Executive Director's Recommendation

Commission Meeting: March 1, 2012

PROJECT Turf and Soil Reconstruction – Phases II and III The National Mall Washington, DC	NCPC FILE NUMBER 7110
SUBMITTED BY United States Department of the Interior National Park Service	NCPC MAP FILE NUMBER 1.41(70.00)43522
	APPLICANT'S REQUEST Approval of comments on concept design
	PROPOSED ACTION Approve comments as requested
	REVIEW AUTHORITY Approval per 40 U.S.C. § 8722(b)(1) and (d)

Figure 7: Alternative 1 - SOM Inspired Design

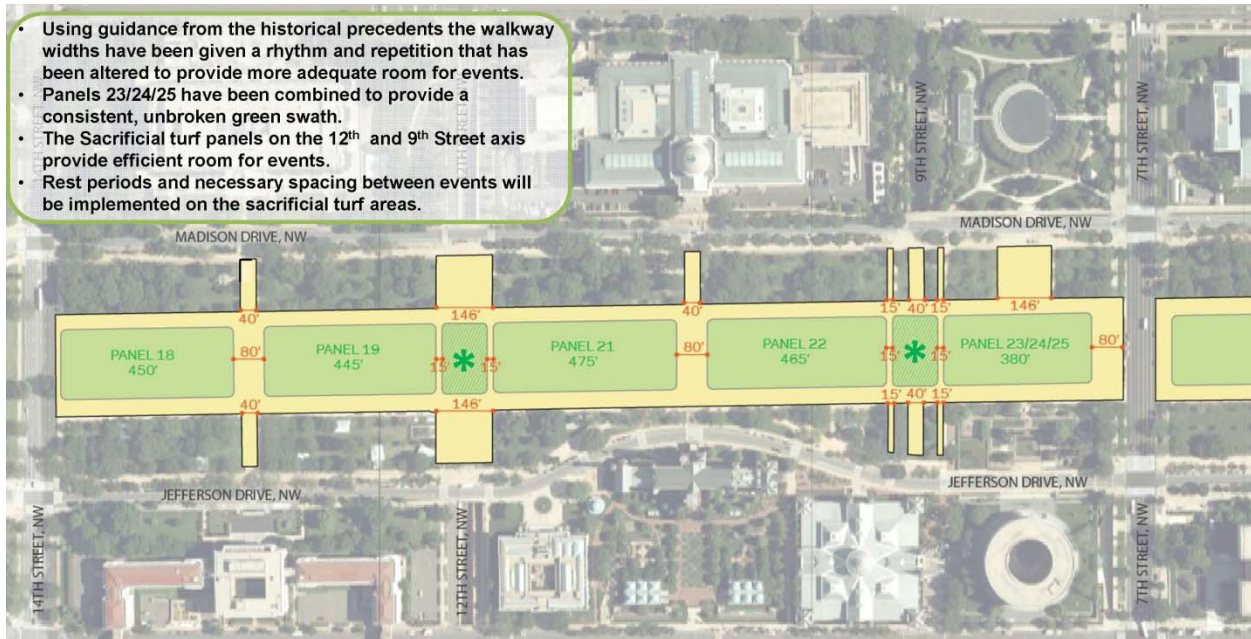
Advantages of Alternative 2 over Alternative 1 include the space on walkways that would be available for tents and equipment during special events. The advantages to this design are that tents and equipment would be placed on gravel and therefore reduce the potential for impacts to the lawn panels. The National Mall plan recommended that the walkways along the Mall be “paved with low-maintenance, sustainable, and universally accessible materials that would be part of a palette of paving materials.” The current project does not include paving the walkways, but NPS anticipates that that the walkways will be paved in the future. The paving material selected for the walkways is an important consideration at this time when modifications to the size and configuration of the walkways is proposed. In selecting the material, there will be aesthetic, historic preservation, sustainability, and maintenance issues to address and therefore

Figure 9: Alternative 3 – McMillan Plan Inspired Design

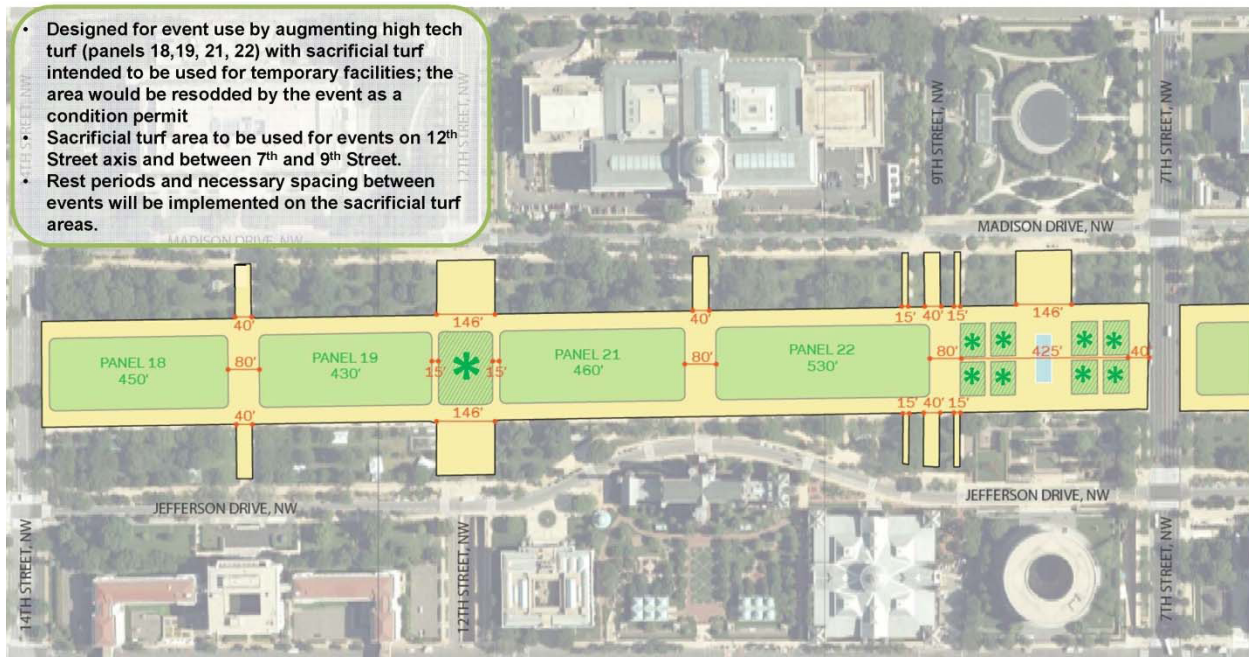
While Alternative 3 takes its cues from the McMillan Plan, the McMillan vision of a plaza and water feature along the 8th Street axis was never implemented. Therefore, if implemented, Alternative 3 would constitute a much more substantial alteration to the Mall and likely have more impacts on historic resources than Alternatives 1 and 2. The introduction of a water feature and the smaller sacrificial turf panels would create the greatest number of alterations to the Mall and would break up the visual consistency of the Mall's lawn panels. However, the plaza would break up the tapis vert; create visual interest and a useful, central gathering space for the variety of events on the Mall; and achieve a worthwhile McMillan Plan goal of providing relief from "the monotony of the meadow-like stretch a mile and a half long" and to provide "seats tempting the passer-by to linger for rest." Though a fixed, raised, formal water feature may not necessarily be the most appropriate solution at this point in time, another type of intervention along the 8th Street axis, perhaps one that could serve multiple purposes and incorporate an unobtrusive water feature, could improve the visitor experience along the Mall and ultimately achieve what the McMillan Plan sought to do in this location. Therefore, staff recommends that the Commission **support the idea of establishing a civic, multi-purpose gathering space along the 8th Street axis that provides additional leisure, recreation, and events space on the Mall, and is planned and designed in a manner that takes into consideration visual impacts, historic preservation, and required maintenance.**

Figure 12: Proposed tent layout on walkways

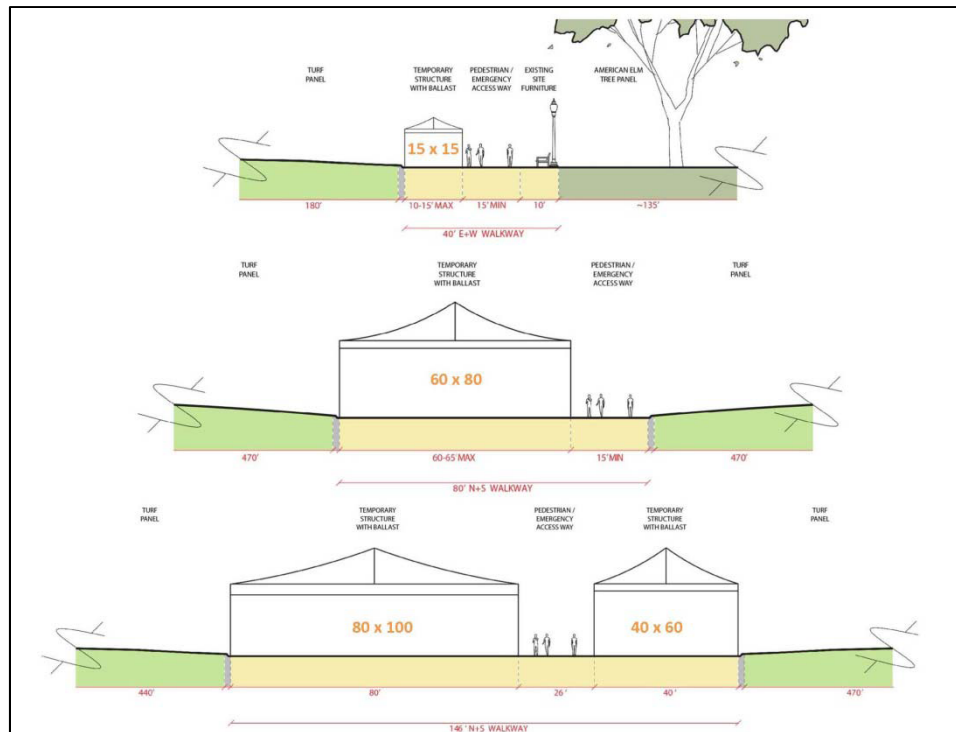
Staff recommends that the Commission **support the project and the National Park Service's efforts to improve the condition of the Mall's turf and ability to accommodate high levels of use for First Amendment demonstrations, national celebrations, and other events by widening the walkways in a manner that will preserve and protect the Mall's historic landscape.** Alternatives 1 and 2 both strive to balance preserving historic characteristics of the Mall and allowing for high levels of use for a variety of event sponsors and types. Both alternatives propose widening north-south walkways from 80 to 146 feet in an effort to create a pedestrian friendly environment while also providing adequate space for equipment and tents. These configurations also allow for the existing continuous visual green lawn or tapis vert effect to remain a key visual component of the Mall. Staff notes that additional information is required in order to completely analyze the appropriateness of the proposed dimensions for the walkways. A 146 wide walkway may cause a significant break in the character-defining green lawn of the Mall and could have adverse effects on the historic landscape.
